Missing pieces of the 802.3dj logic baseline

**IEEE P802.3dj Joint Logic/Optics Ad Hoc Meeting
November 2, 2023**

Mark Gustlin – Cisco
Arthur Marris - Cadence
Gary Nicholl - Cisco
Matt Brown - Alphawave

Figure 170–1—RS and MII relationship to the ISO/IEC Open Systems Interconnection (OSI) reference model and IEEE 802.3 Ethernet model

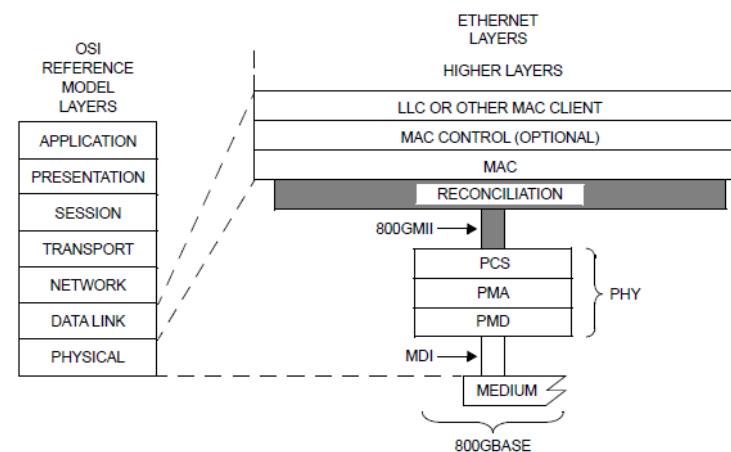
- Add 1.6Tb/s to clause 170 (MII)
 - In addition to the existing 800 Gb/s rate
- The 1.6TMII has the following characteristics:
 - a) It supports a speed of 1.6 Tb/s.
 - b) Data and delimiters are synchronous to a clock reference.
 - c) It provides independent 64-bit wide transmit and receive data paths.
 - d) It supports full duplex operation only.
- Make other changes as necessary
 - Update Figure 170-1 to add the 1.6T stack (similar to Figure 117-1)
 - Delay constraints are on the next page

Figure 171-1—800GXS relationship to the ISO/IEC Open System Interconnection (OSI) reference model and the IEEE 802.3 Ethernet model

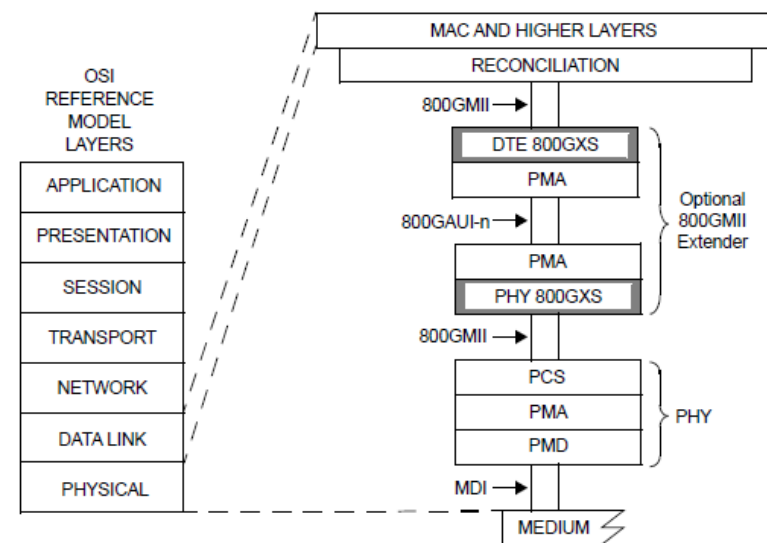
- Add 1.6Tb/s to clause 171 (XS)
 - In addition to the existing 800 Gb/s rate
 - Add the 1.6T stack into figure 171-1
- The following is a list of the major functions of the 1.6TMII Extender:
 - Simple signal mapping to the 1.6TMII
 - The optional 1.6TMII Extender can be inserted between the Reconciliation Sublayer and the PHY to transparently extend the reach of the 1.6TMII
 - Independent transmit and receive data paths
 - Each 1.6TXS leverages all functions in the 1.6TBASE-R PCS (see Clause TBD, placeholder 301)
 - Each 1.6TXS connects to a 1.6TAUI-n as shown in Figure 171-x
- Make other changes as necessary, including:
 - Diagram equivalent to figure 171-2 (functional block diagram), 171-3 (layering); but for 1.6T
 - Tables equivalent to tables 172-2, 172-3, 172-4, 172-5 status and control variable mapping; but for 1.6T
 - Service interface definitions, FEC degrade signaling etc.
